BOARD OF DIRECTORS' MINUTES | SPORTS CAR CLUB OF AMERICA, INC. | Feb. 6-10, 2008

CRB Conference Call – January 7, 2008

Fig 1

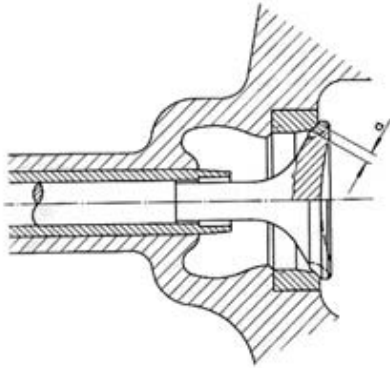
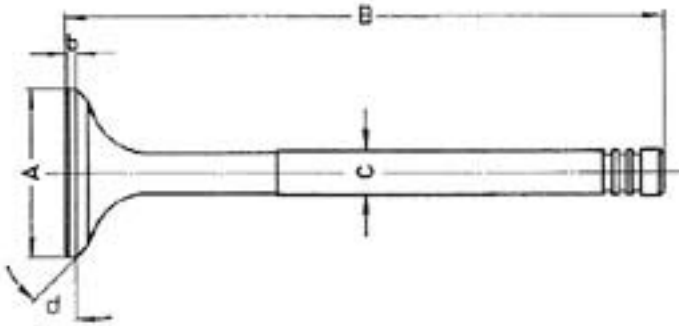
5.6.5. Valves and valve seats may not be reshaped. Valve to valve seat mating surface (figure 1) shall be cut as follows. The 45 deg valve seat width (figure 2) shall be maintained by cutting a 15 deg chamfer (figure 3) at the outside edge of the seat and a 75 deg chamfer (figure 4) at its inner edge. Seats cannot be refaced if too little material remains for a 15 deg chamfer to be cut without going beyond the boundary of the insert. If the chamfer extends to the head, the seat or the head must be replaced.

5.6.5.1. Valve specifications (figures 1 & 5):

Dimension "a" – valve seat contact width: Intake – 1.30 mm to 1.60 mm
 Exhaust – 1.70 mm to 2.00 mm Seat contact angle on valve: 45 deg Intake and Exhaust
 Dimension "A" – valve head dia: Intake – 35.56 mm max. Exhaust – 32.06 mm
 Dimension "B" – valve length: 110.5 mm to 112.5 mm
 Dimension "C" – valve stem dia: Intake – 7.94 mm min. Exhaust – 7.91 mm
 Dimension "b" – valve head margin: Intake – .80 to 1.50 mm Exhaust – 1.00 to 1.70 mm
 Dimension "d" – face angle of valve only: Intake - 44 deg Exhaust - 45 deg

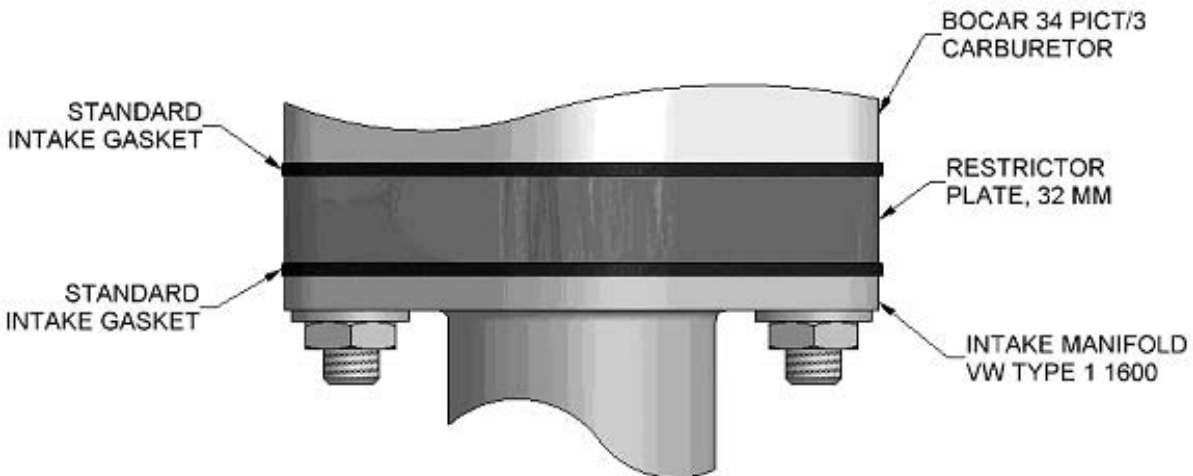
5.10.4. The standard 1600 manifold end castings must be untouched internally other than for the purpose of port matching.

5.10.5. Port matching to a depth of 1.0" into the manifold casting from the manifold/head joining surface is permitted.
